Diversified Environmental Catalysts

Tech-Note

Technical Service BULLETIN

M.I.L. "ON" DTC P0171 AND/OR P0174: ENGINE RUNNING LEAN

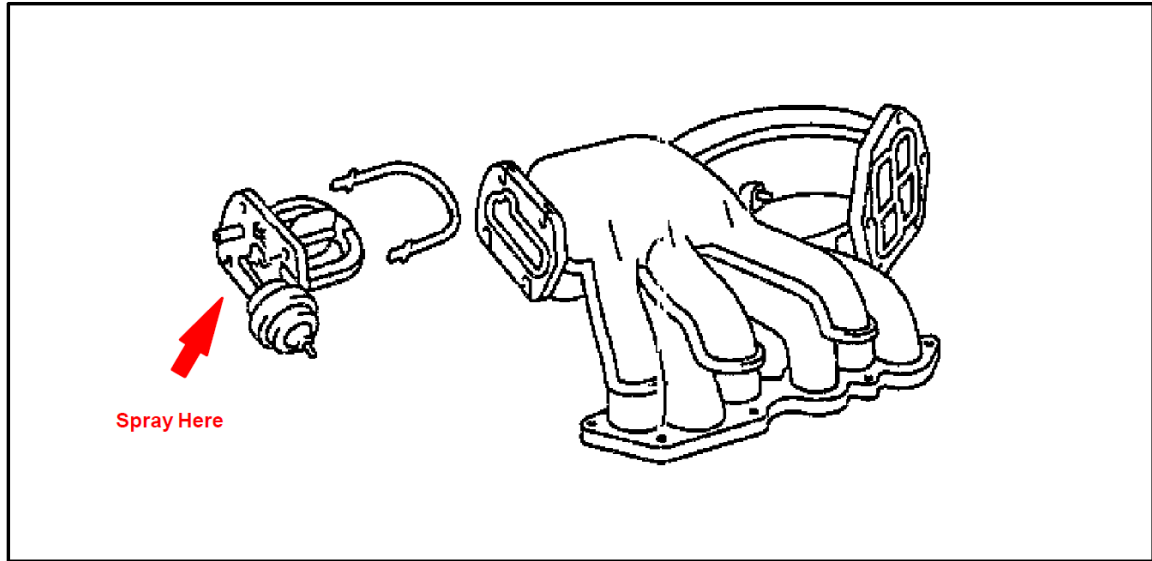
2. Spray carburetor cleaner near the Intake Air Control Valve pivot shaft and monitor Short Term Fuel Trim as indicated in step 1.

3. Was the short term fuel trim changing to a rich reading, or negative fuel trim in step 2?

If Yes – Replace the Intake Air Control Valve. Refer to the Technical Information System (TIS), 2004 model year applicable model Repair Manual: *Intake: Intake Air Control Valve Assy No. 2 (3MZ-FE): Replacement.*
